Re: UE 394 – In the Matter of Portland General Electric Company, Request for a General Rate Revision.

Errata to CUB's Exhibits for Inclusion in the Administrative Record.

2019 Integrated Resource Plan.

Staff of the Public Utility Commission of Oregon (OPUC or Commission) submits these Opening Comments on Portland General Electric's (PGE or Company's) 2019 Integrated Resource Plan (IRP or Plan), filed on July 17, 2019 and Interim Transmission Solution Addendum filed on August 30, 2019. Staff will continue to evaluate the Company's Plan, conduct discovery, and review stakeholders' comments prior to submitting its Final Comments, currently scheduled to be filed on December 3, 2019.

FIGURE 7-13: Cost versus variability for the preferred portfolio

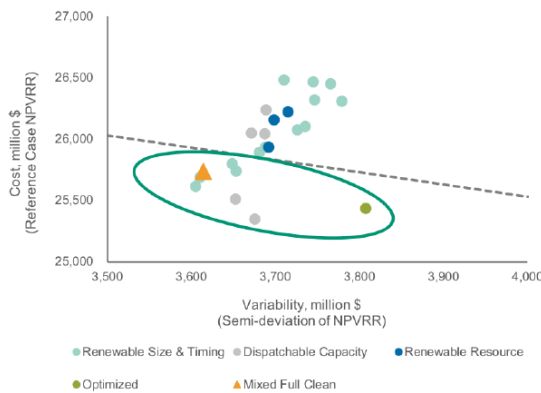
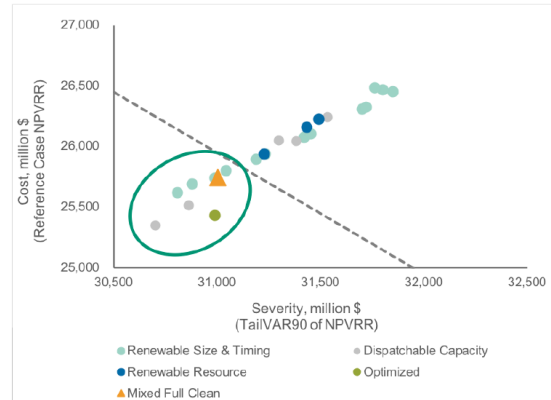
This approach to constructing a new preferred portfolio based on “reasonable actions” from other well performing portfolios is somewhat puzzling, and may present another blunt instrument in portfolio selection. Staff finds this approach particularly curious given that the Mixed Clean Full is outperformed by others in terms of cost and risk, as shown by PGE’s graphics:²⁰

PGE should provide an analysis comparing its preferred portfolio to other top-performing portfolios for cost and risk, and explain why the Company believes it has chosen a portfolio with the best balance of cost and risk, as required by the IRP guidelines.

Recommendation 4: As PGE adjusts its IRP analysis in accordance with Staff's comments, including the removal on non-traditional screens, PGE should provide additional information:

- Provide a quantitative comparison of its preferred portfolio to other well-performing portfolios in terms of NPVRR cost and risk.
- Explain why the Company believes its preferred portfolio has the best balance of cost and risk for customers.

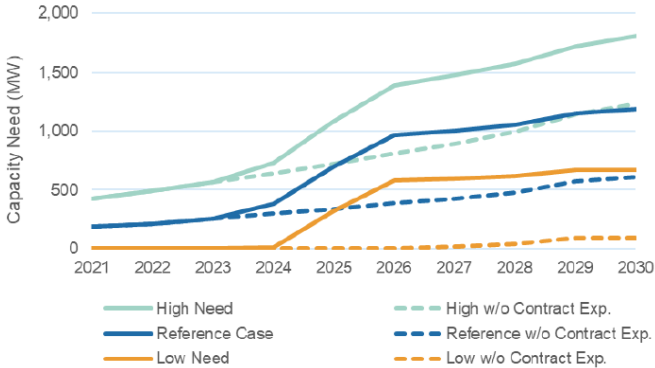
Staff is currently reviewing the forecasted range of capacity needs in the 2019 IRP, which it finds is strikingly broad. Staff is motivated to ensure that the Company gives adequate considerations to capacity adequacy, particularly given the robust discussions in Chapter 3 Futures and Uncertainties and the regional capacity need shown by recent studies evaluated in the Market Capacity Study.⁵⁹

PGE forecasts wide “jaws” of capacity need by 2025, ranging from a low of 0 MW to a high of nearly 1,100 MW of new capacity. The graphic below captures the wide range of possible need.⁶⁰

FIGURE 4-17: Load and existing and contracted generation

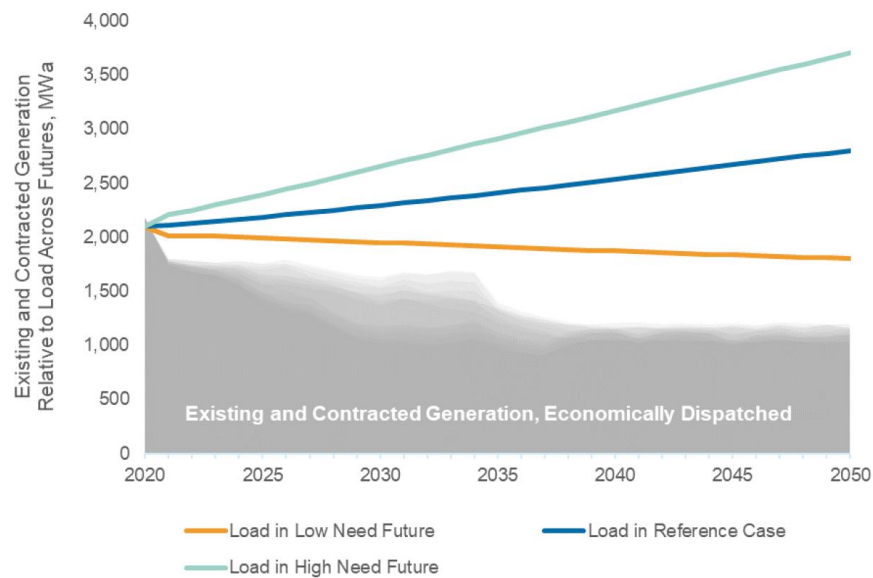
PGE’s new market energy position analysis provides an interesting evolution of the Company’s traditional load-resource balance. Through this analysis, PGE models economic dispatch and compares it to three need futures to demonstrate what it describes as an “energy shortage” (See Figure 4-17).⁶⁶

Yet, when PGE’s resources dispatch economically and market purchases meet the rest of PGE’s load, this is not necessarily an indication that PGE needs to acquire more energy resources. It may simply indicate that market prices are low. PGE’s ‘Market Energy Position’ analysis tells how much energy the company may choose to buy on the market, but in no way should it be used to justify any amount of new resource acquisition.

FIGURE 6-15: Net cost sensitivities for wind

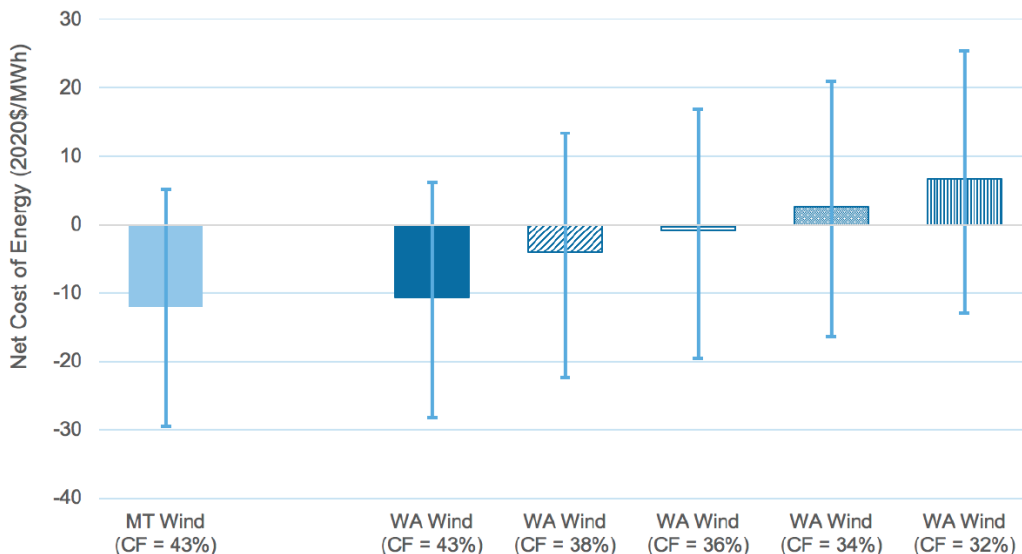
Staff notes the impact that capacity factor assumptions have on the economic performance of wind resources in PGE’s sensitivity and questions whether the Company’s sensitivity analysis should have been performed on the Mixed Full Clean portfolio to help characterize the risk of acquiring near-term wind assets based primarily on economic performance.

Recommendation 20: Staff requests that PGE provide a sensitivity analysis of the Mixed Full Clean portfolio assuming proportionate changes to the capacity factor of each resource as the assumptions behind the capacity factor sensitivity analysis in Figure 6-15 above.

FIGURE 5-4: Average monthly wind capacity factors by location

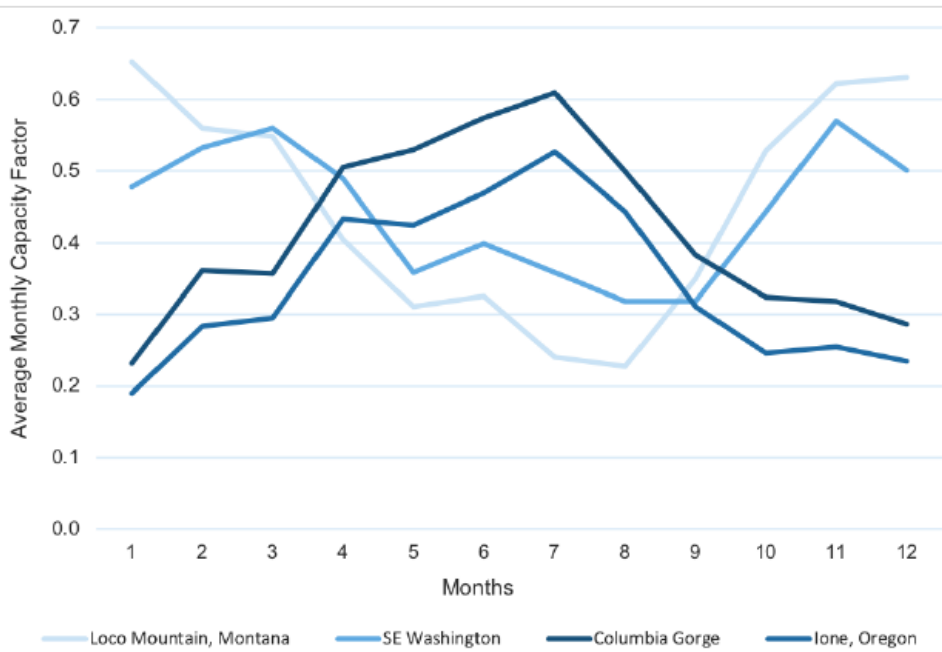
Further, Staff is curious about the relationship between the capacity factor shape of different wind resources modeled in the IRP and PGE’s projected capacity needs. For example, PGE provided a helpful characterization of different wind resources’ capacity factor shapes in Figure 5-4.⁹⁰ Staff notes that the performance of Columbia Gorge and lone, Oregon wind follow the reverse shape to that of Montana and Washington wind.

FIGURE 4-14: Reference Case loss-of-load expectation in 2025

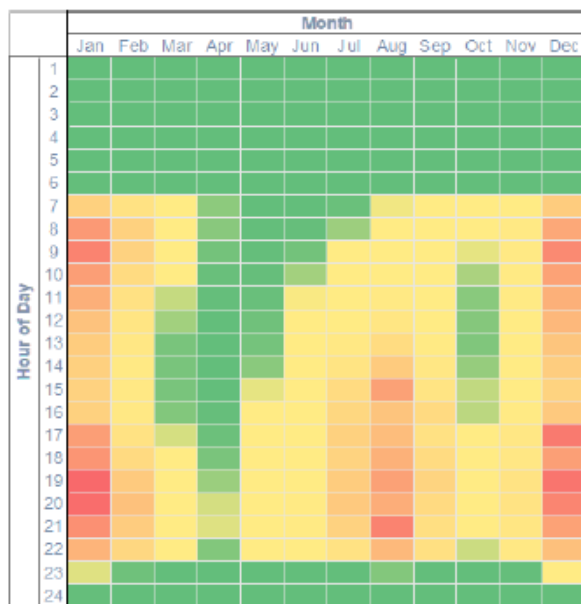
Given the Action Plan’s lack of specificity regarding resources in the renewable RFP and the future capacity actions, it is particularly interesting to note the relationship between the wind shapes and PGE’s characterization of its capacity need found in figure 4-14.⁹¹
